VALUE ENGINEERING STUDY

**PI No. 621340-
SR 5 from SR 2 to Proposed McCaysville Bypass**

**PI No. 620490-
McCaysville Bypass from SR 5 to Tennessee State Line
Fannin County, Georgia**

Sept. 1, 2016

PROPOSAL NUMBER: R-2.1 **PAGE NUMBER:** 3 of 4

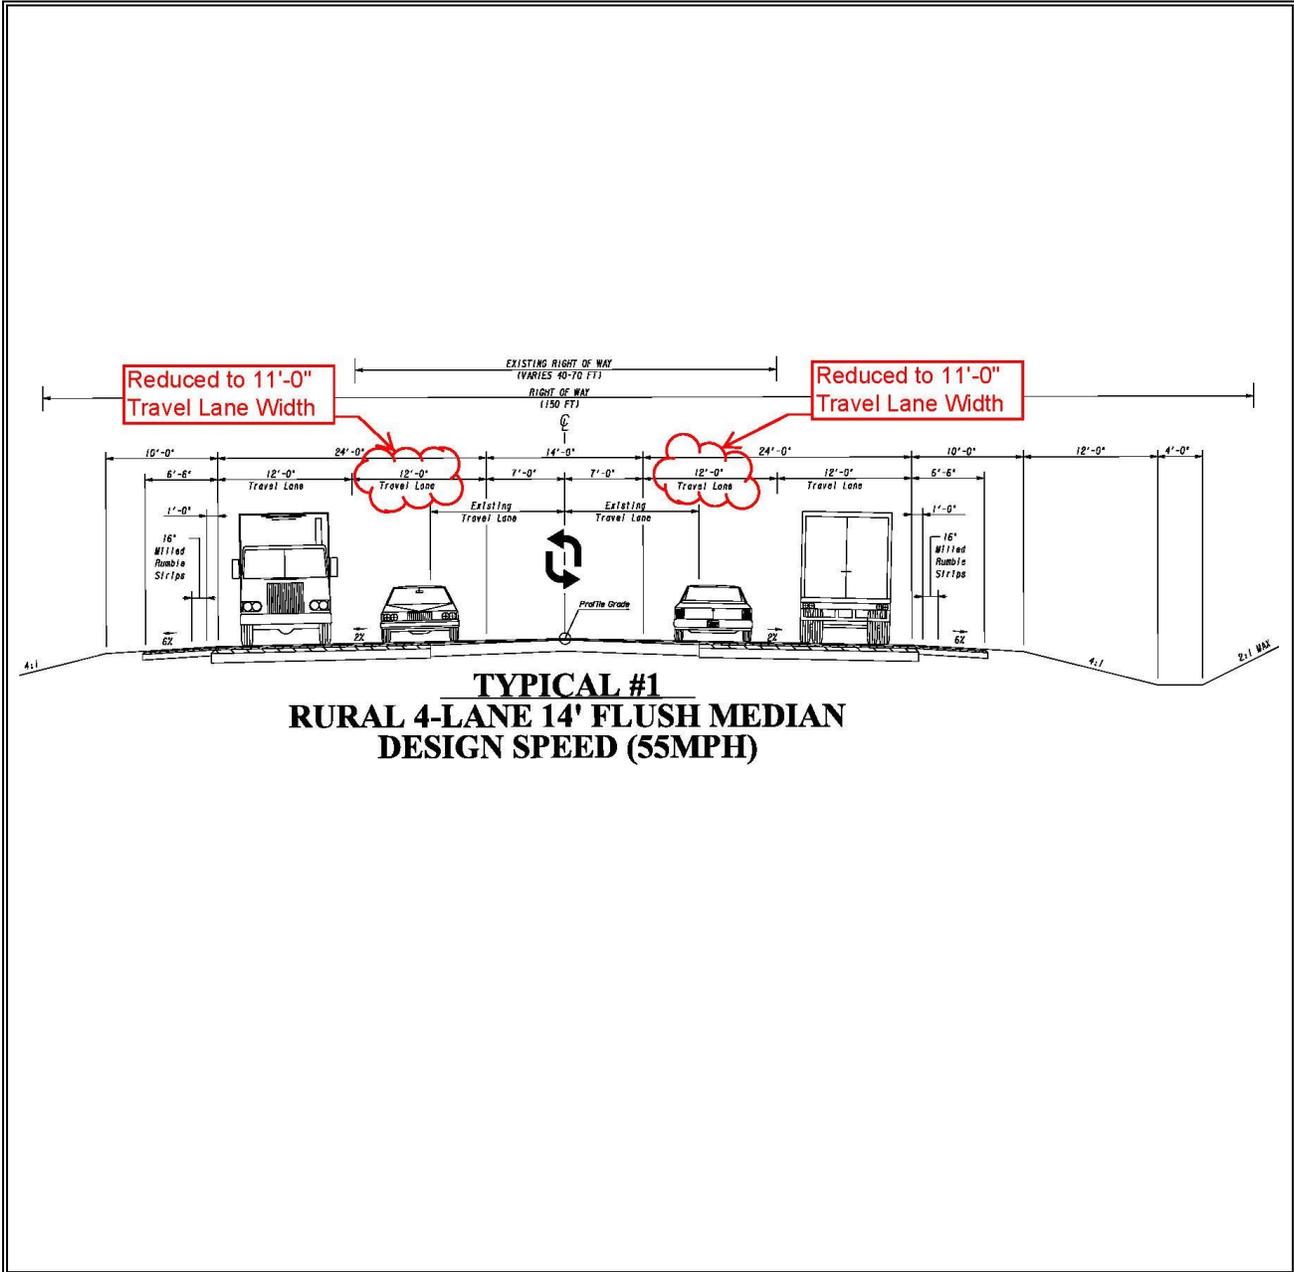
PROPOSED CHANGE: The proposed change is to reduce the inside 12-foot-wide travel lane in each direction to an 11-foot-wide travel lane in each direction. No other width changes are proposed for the remaining lanes to the proposed typical section.

JUSTIFICATION: GDOT routinely accepts 11-foot travel lanes in Arterial designed roadways. Per the latest GDOT Design Policy Manual Table 6.6, Design Criteria for Arterial Roadways, 11 foot lanes are allowed for 4-lane roadway sections at 55 MPH design speed with ADT's over 2,000. A Design Variance or a Design Exception will not be required for this change. With 9% truck volume projected on this project, it was decided by the VE Team to not reduce the outside lane width to 11 feet.

PROPOSAL NUMBER: R-3.0 **PAGE NUMBER:** 3 of 5

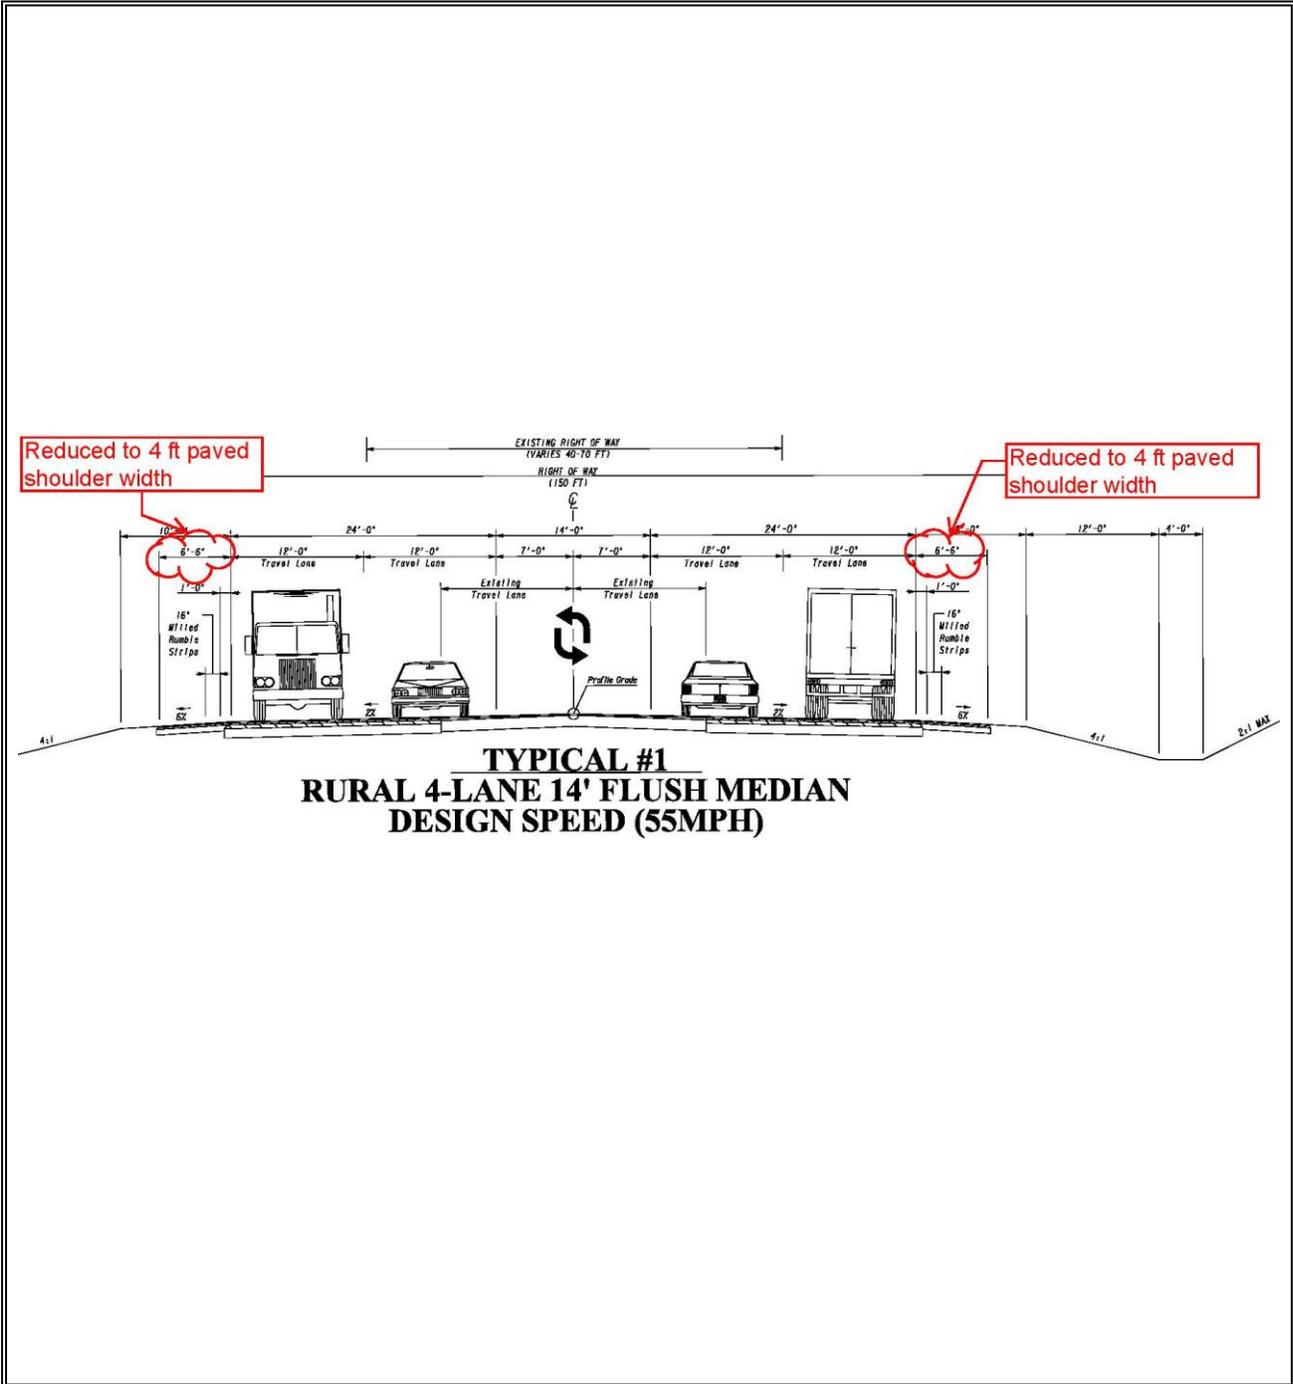
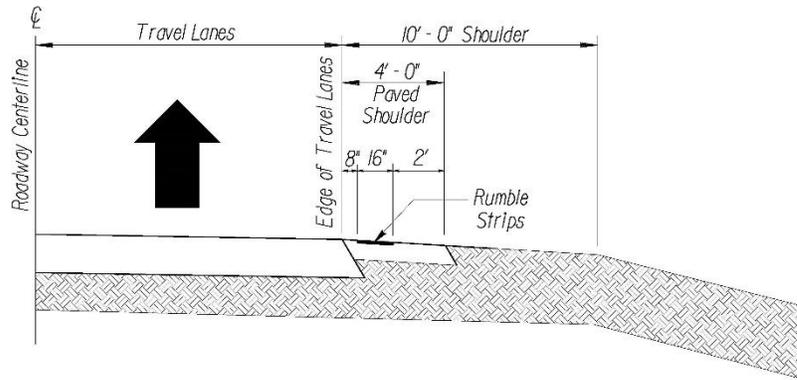
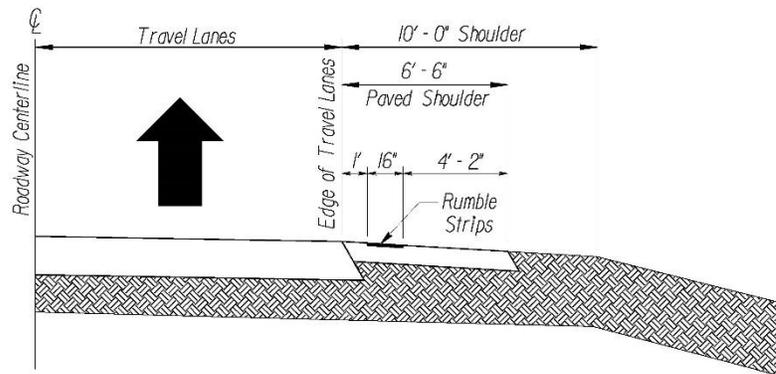
PROPOSED CHANGE: The proposed change is to reduce the paved shoulder width to 4 feet. The shoulder section will remain as partial depth.

JUSTIFICATION: The GDOT Design Policy Manual Table 6.6, Design Criteria for Arterial Roadways, states that 6.5-foot paved shoulder should be used for 4-lane roadway sections at 55 MPH design speed with ADT's over 2,000. Note 4 in that table states that Bike Lane is incorporated into the overall width of a 6.5-foot paved shoulder to include a 16-inch rumble strip and total 12-inch buffer area (refer to Ga. Construction Detail S-8). However, AASHTO's Policy of Geometric Design of Highways and Streets, 2011-6th Edition section 7.2.3 states, as a minimum, 0.6 m [2 feet] of shoulder width should be paved to provide for pavement support, wide vehicles, and collision avoidance. As shown on GDOT Construction Detail S-8, Milled Rumble Strips and Bicycle Accommodation Details, the 6.5-foot paved shoulder appears to be used where 4-foot-wide bike lanes are required on paved shoulders with rumble strips. As stated in the concept report SR 5 is not a designated bike route in the Statewide Bicycle Plan, nor did it meet any of the Complete Street Warrants, thus bike lanes are not being required. Since the proposed paved shoulder widths meet AASHTO but not GDOT Design Policy, a Design Variance will be required for this change.

PROPOSAL NUMBER: R-1.0 PAGE NUMBER: 3 of 4

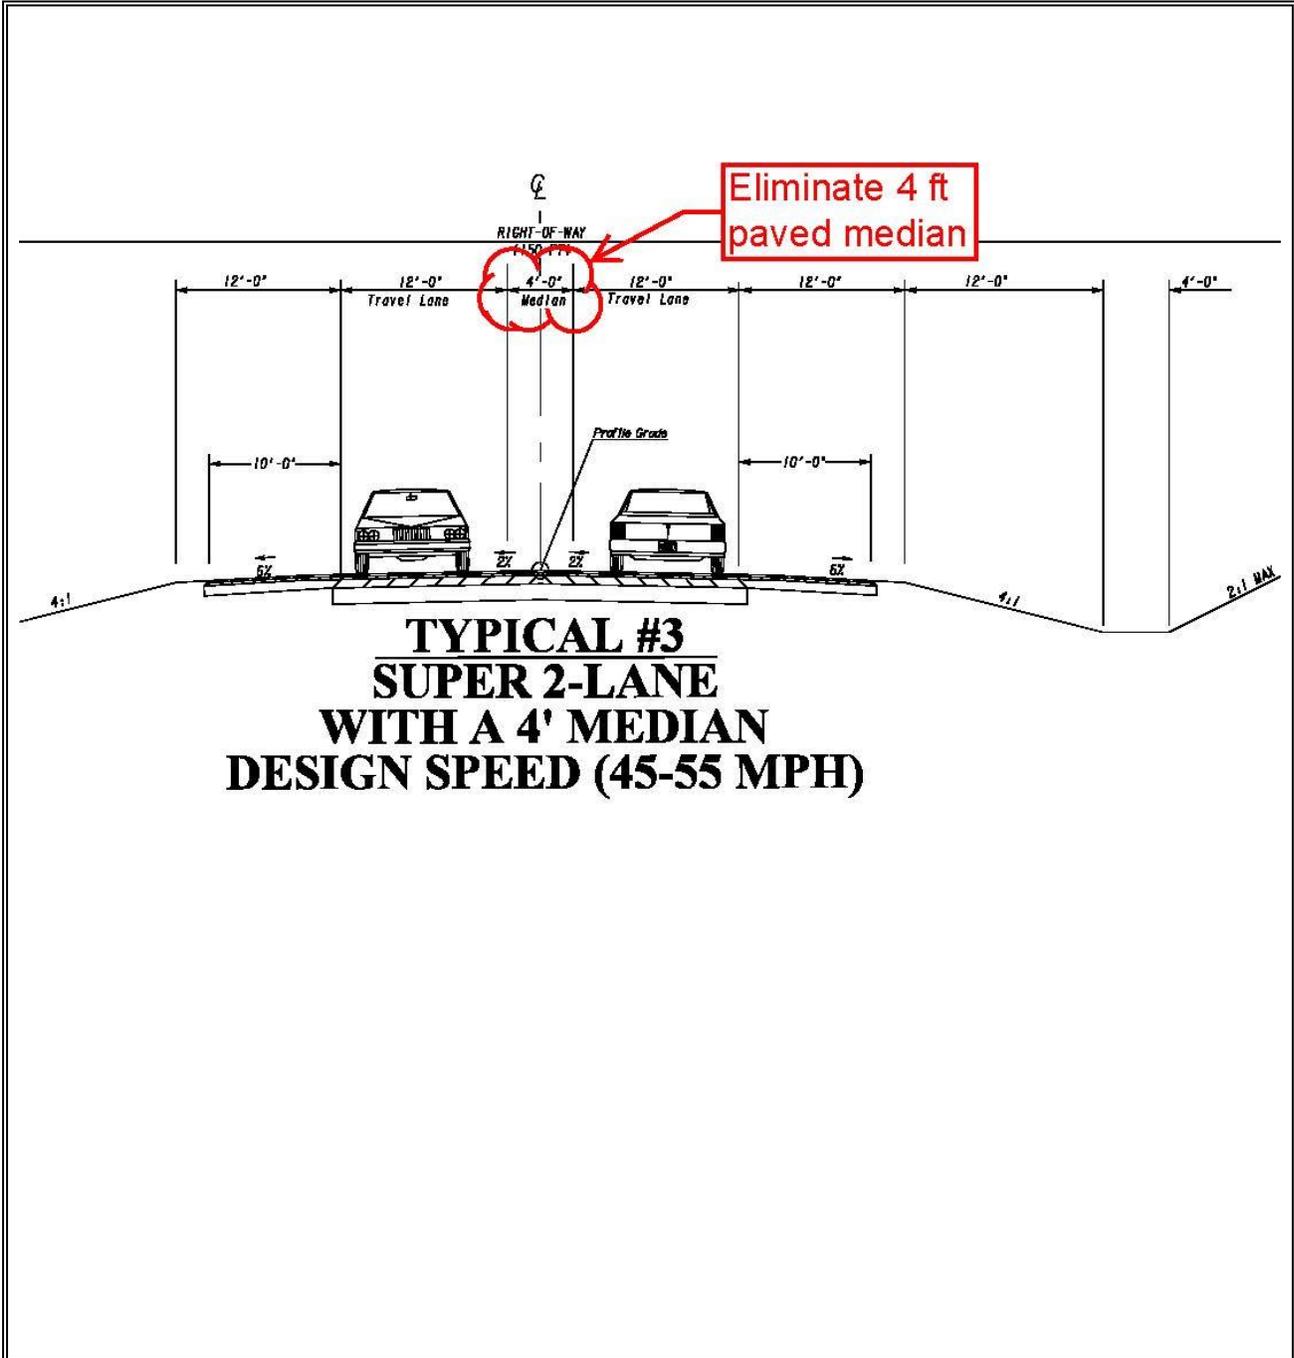
PROPOSED CHANGE: It is proposed to eliminate the 4-foot wide flush asphalt median for the 2 lane section of the truck bypass. It is also proposed to reduce the clear bridge width by 4'-0" for Bridges 1 thru 4.

PROPOSAL NUMBER: R-2.1 PAGE NUMBER: 3 of 4

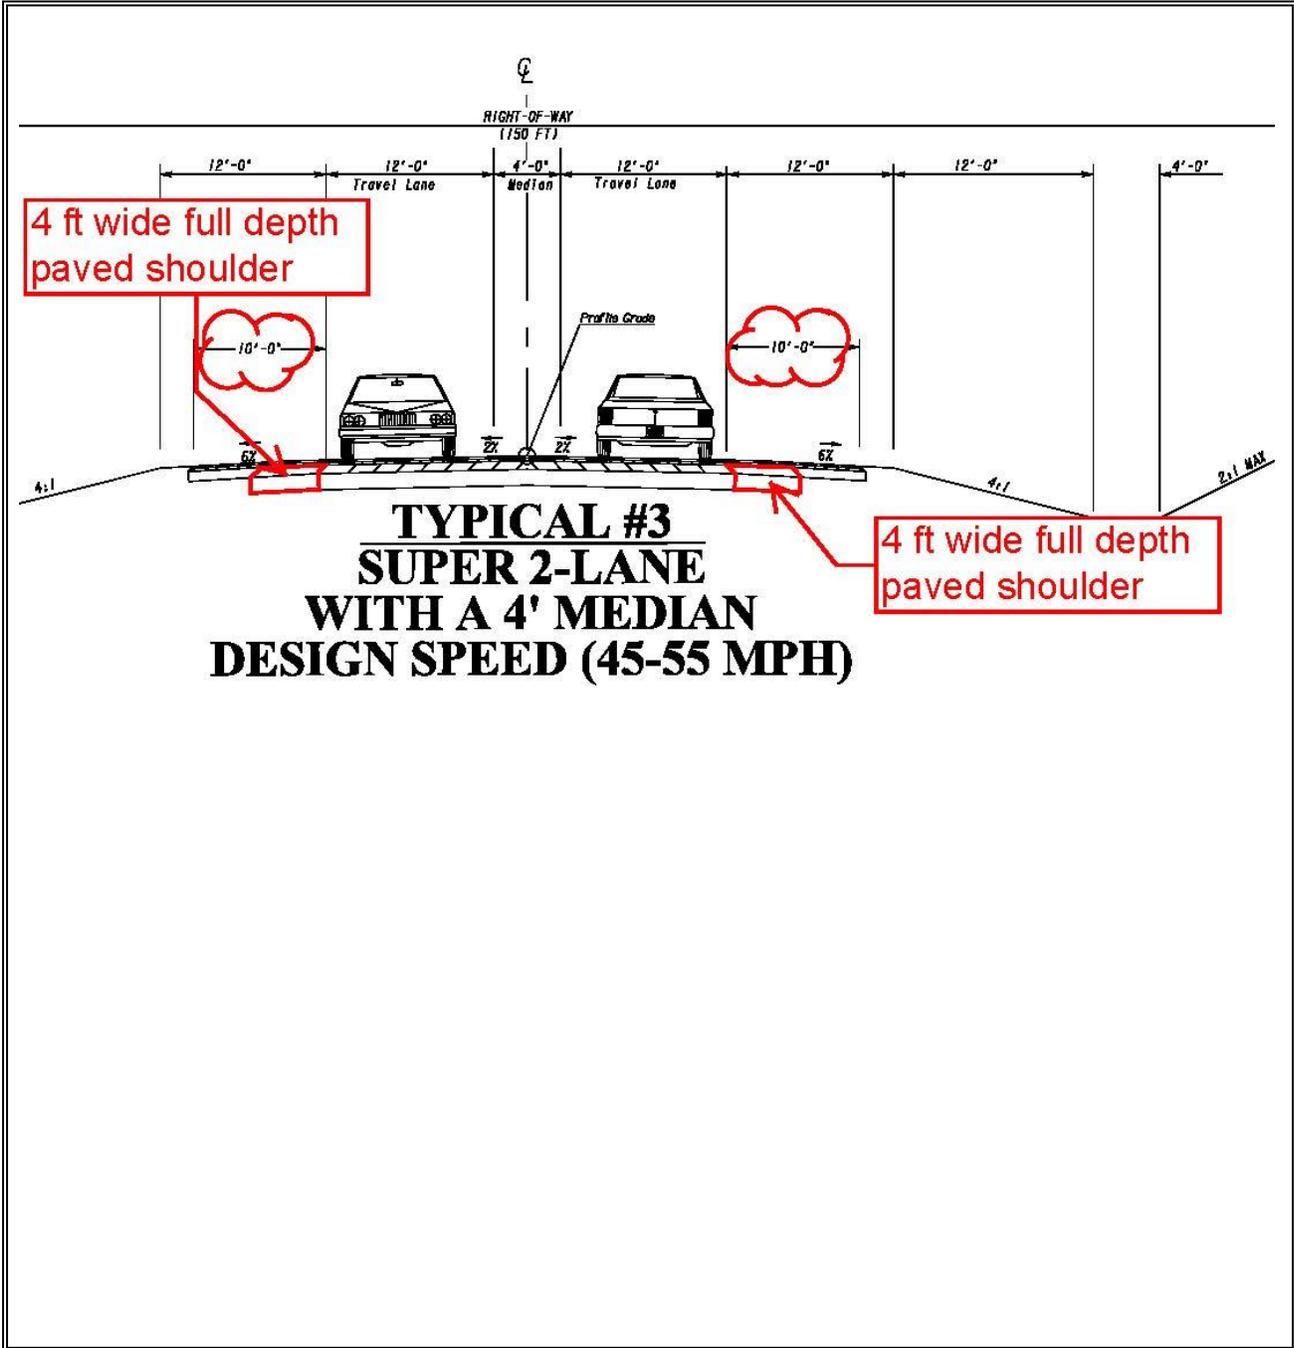
PROPOSED CHANGE: The proposed change is to reduce the 10-foot partial depth asphalt shoulder to 4-foot full depth asphalt shoulder in the 2-lane section of the truck bypass.

JUSTIFICATION: The GDOT Design Policy Manual for Collector Roadways does not have a listing for 55 MPH 2-lane roadways in Table 6.5. Table 6.4 in the GDOT Design Policy Manual for Local Roadways at 55 MPH for 2-lane roadways, the graded shoulder is 10 feet wide with 2 feet paved. AASHTO’s Policy of Geometric Design of Highways and Streets, 2011-6th edition section 7.2.3 states, as a minimum, 0.6 m [2 feet] of shoulder width should be paved to provide for pavement support, wide vehicles, and collision avoidance.

Also as stated in the concept report, SR 5 is not listed as a designated bike route in the Statewide Bicycle Plan nor did it meet any of the Complete Street Warrants, thus bike lanes will not be required. Since bike lanes are not warranted, the VE Team believes that 4-foot full depth shoulders should be sufficient for the truck bypass route.

PROPOSAL NUMBER: R-5.0 **PAGE NUMBER:** 3 of 4

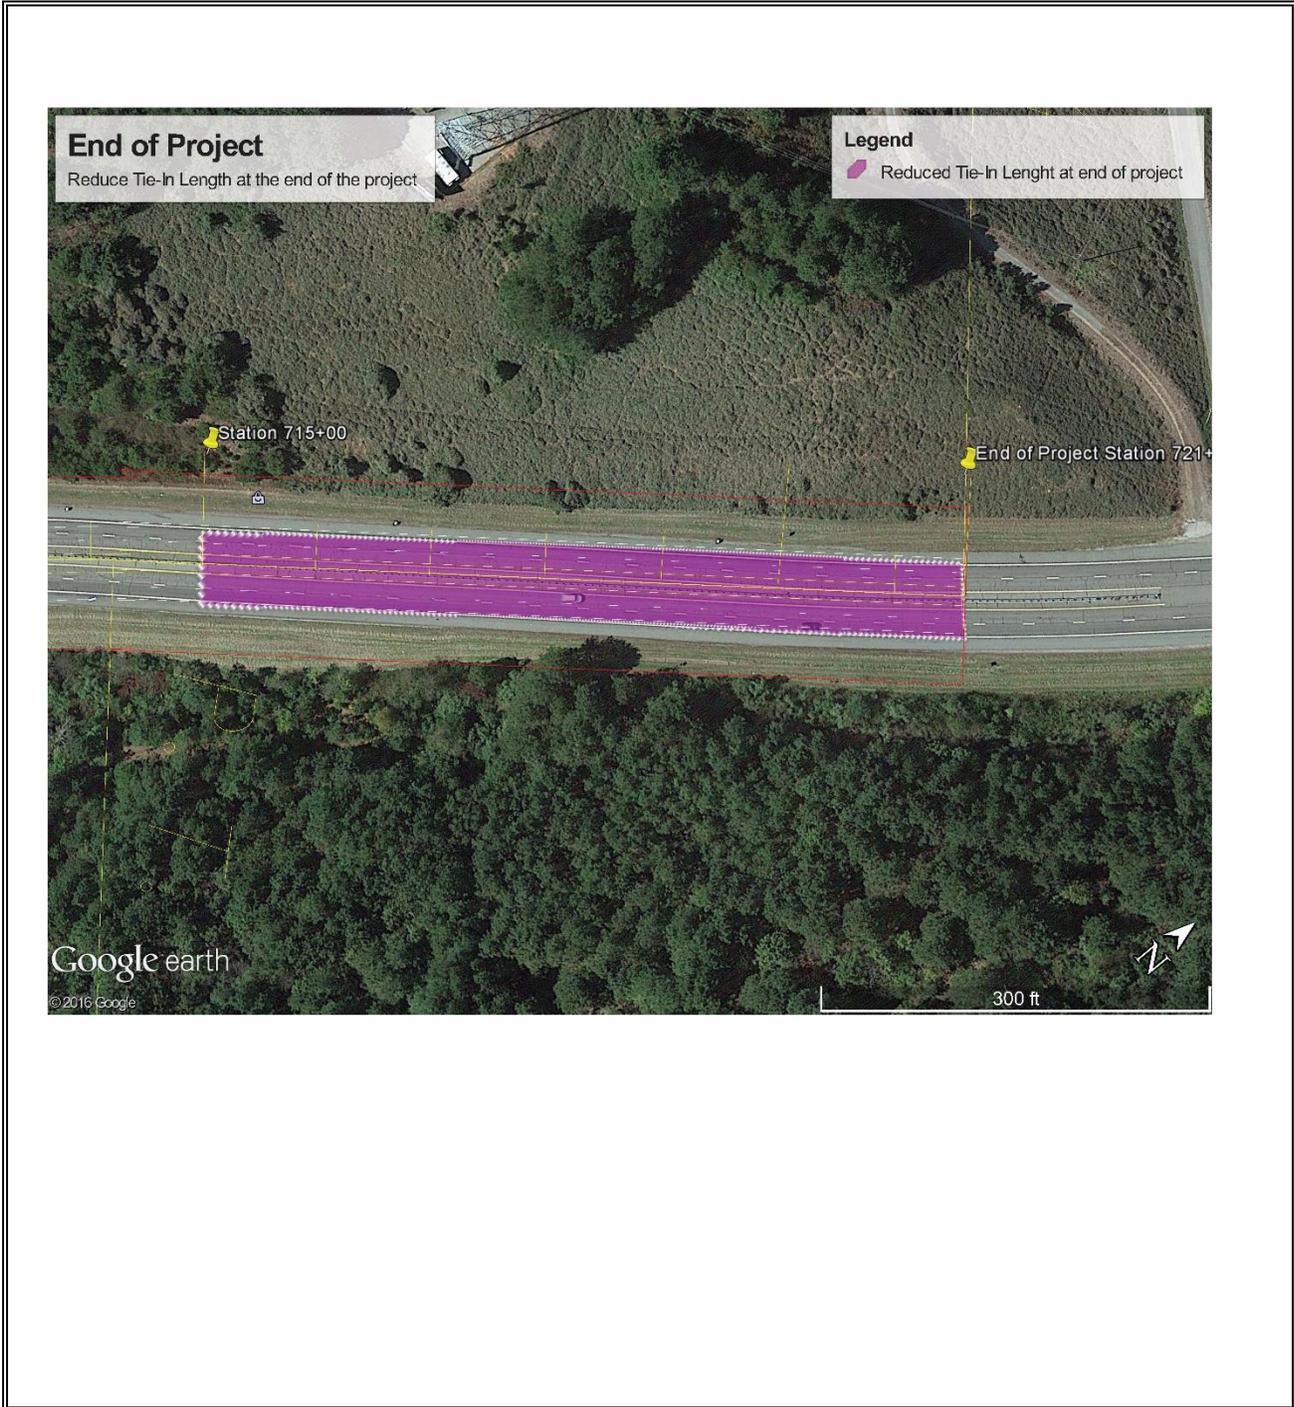
PROPOSED CHANGE: It is proposed to adjust the end of project to approximate Sta 715+00, resulting in a reduction of 658 feet of road work.
